BAR Meeting  
September 21, 2011

**ISSUE:** Partial Demolition/Encapsulation and Additions  
**APPLICANT:** Katherine Reid  
**LOCATION:** 734 South Royal Street  
**ZONE:** RM / Residential

**BAR CASE #2011-0249 & 0250**

Figure 6: Existing Jefferson Street View (South Façade)

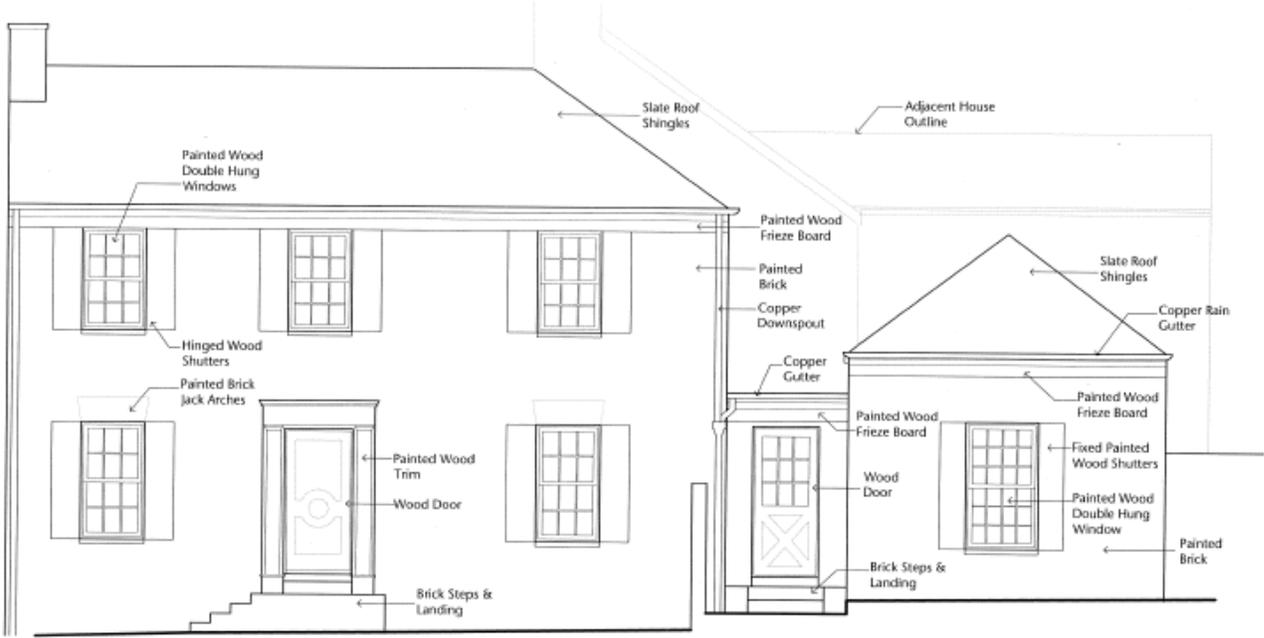
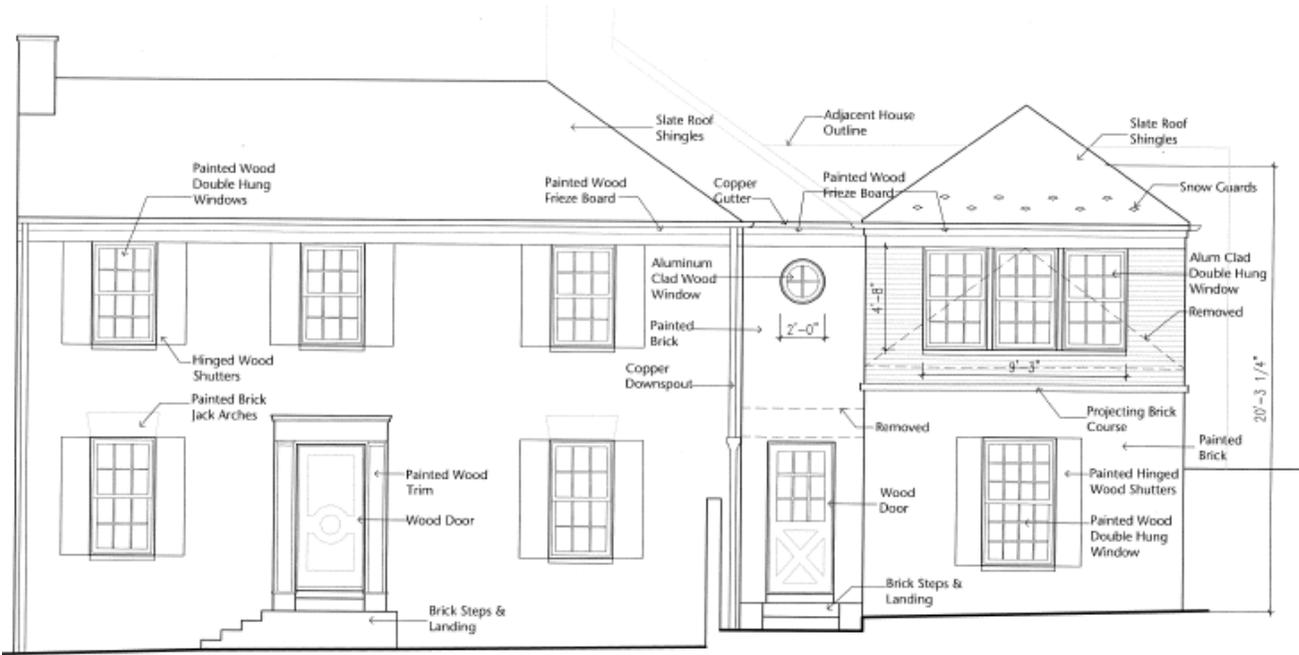
In this case, staff suggested that the original, somewhat utilitarian gable roof proposal be revised to retain some of the garden pavilion character of the existing pyramidal roofed addition. In addition, replacement of the front gable with a pyramidal roof form for the addition tends to make it visually recede from the main building façade. Finally, the additional second floor windows visually reduce the mass of the addition and distinguish it from the original house. This more conservative design approach is very different from the Modernist, somewhat bombastic greenhouse style addition the Board recently reviewed at 333 Green Street, yet it achieves the same programmatic and preservation goals.

As the attached drawings illustrate, the proposed addition will not overwhelm the existing building and will continue to read as separate and distinct elements due to the change in the roof structures, the use of recesses and projections on the wall surface and the change in fenestration. The proposed additions are generally appropriate in respect to massing, scale and form, and are consistent with many of the additions found adjacent to the subject property, especially along Jefferson Street and throughout the district. The use of frame construction clad in brick veneer and retaining the existing rooflines, results in an appropriately simple addition for this modest townhouse. Finally, the proposed materials are high quality, appropriate and compatible with the historic building.

Figure 11: Proposed East (Rear) Elevation

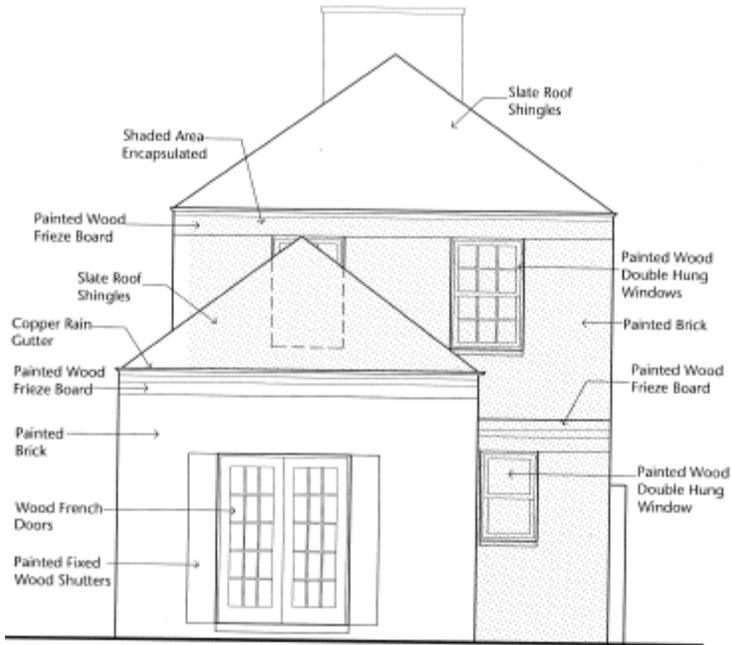
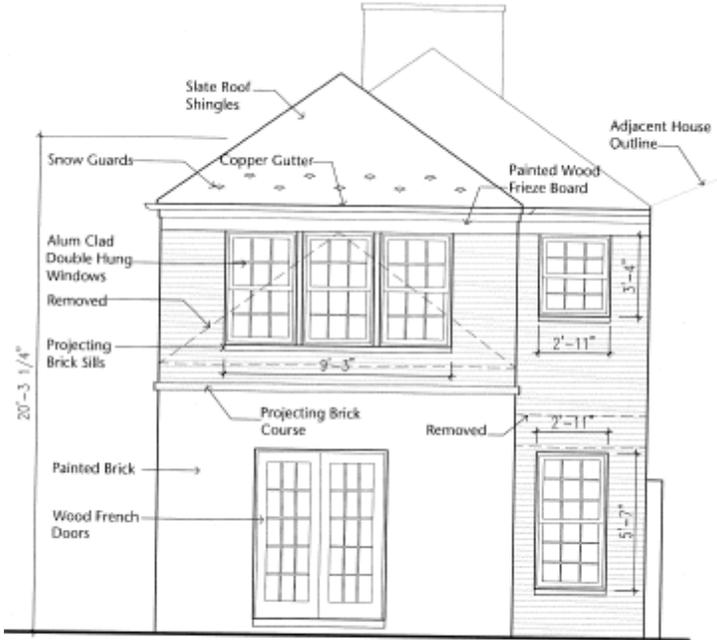
- Removal of the rear wall the one-story flat roof addition (c1973) addition (approx. 50 sq. ft.)
- Removal the existing second floor windows on the original 1941 rear elevation and modify openings to provide access into new second floor addition.
- Encapsulation of the rear wall on the second floor of the original 1941 rear elevation extension (approx. 150 sq. ft.)

The proposed new addition and rear extension are designed to accommodate a new bedroom on the second floor. The south and east elevation of the new, second floor pyramidal roofed addition will have three, six-over-six, double-hung windows and a brick belt course. The second floor of the hyphen will be detailed with an ocular window and a flat roof. The two-story rear extension will have a nine-over-nine window on the first story and a six-over-six window on the second. The broad flat frieze and molded cornice on the existing main block will be continued onto the new additions. The proposed materials include: aluminum-clad simulated divided-light, wood windows; slate roof, painted, brick veneer; and copper gutters and downspouts.
